MIL-M-28787/42B(SH)
AMENDMENT 2
19 March 1992

MILITARY SPECIFICATION

MODULES, STANDARD ELECTRONIC

COMPARATOR, MAGNITUDE, DIGITAL, KEY CODE JBK

FIGURE 5. V_{OUT} (low-loaded) test circuit for table III.

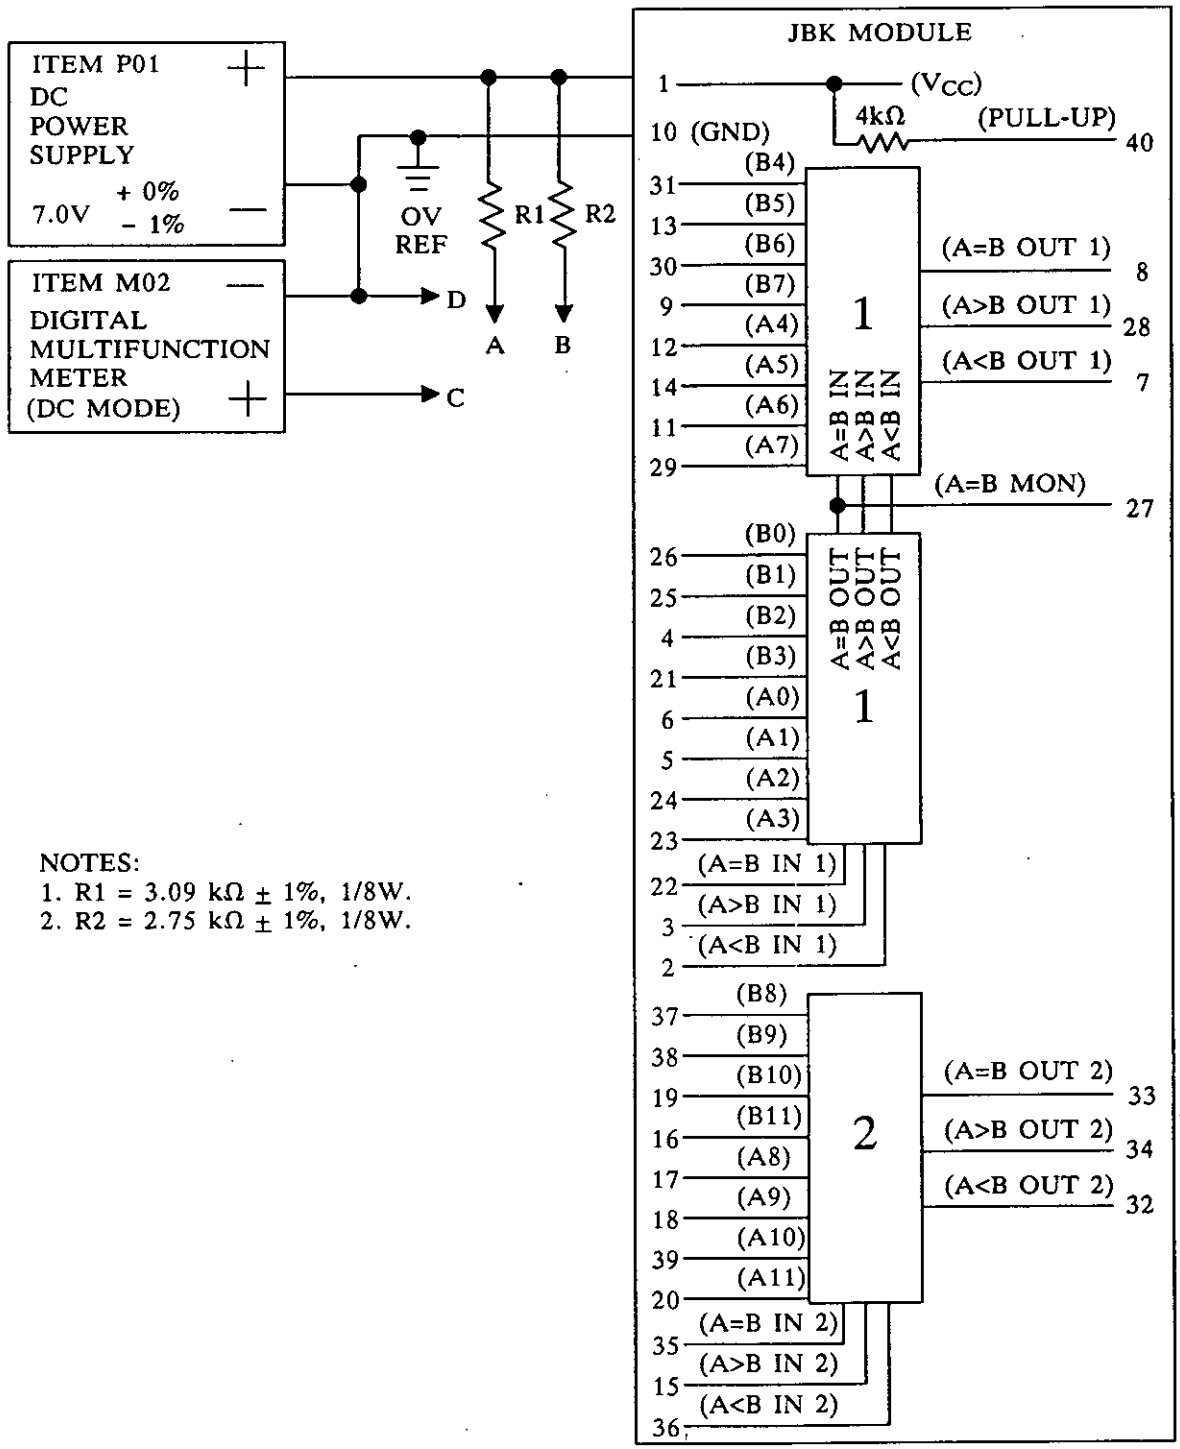
FIGURE 5: Delete and substitute new figure 5 as printed on page 3 of this amendment.

NOTES:
1. R1 = 3.09 kΩ ± 1%, 1/8W.
2. R2 = 2.75 kΩ ± 1%, 1/8W.

FIGURE 9. Functional compare and output voltage (high-level and low-level) test circuit for table VII.

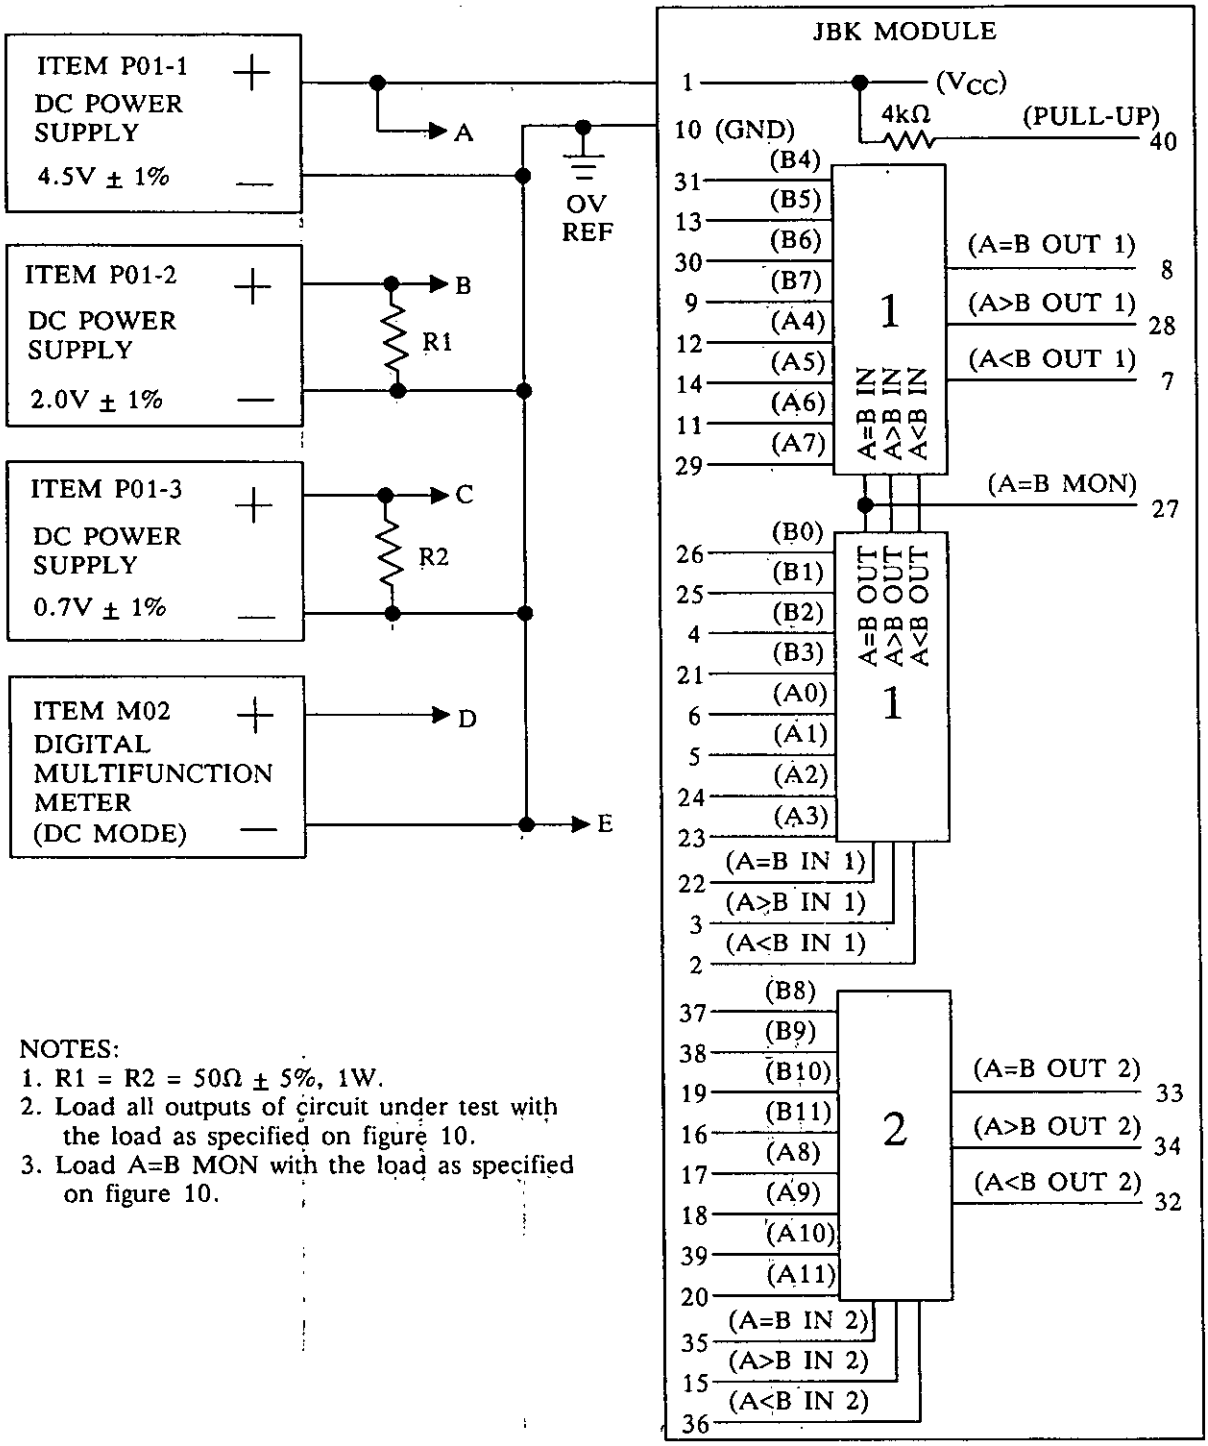
FIGURE 9: Delete and substitute new figure 9 as printed on page 4 of this amendment.

NOTES:
1. R1 = R2 = 50Ω ± 5%, 1W.
2. Load all outputs of circuit under test with the load as specified on figure 10.
3. Load A=B MON with the load as specified on figure 10.
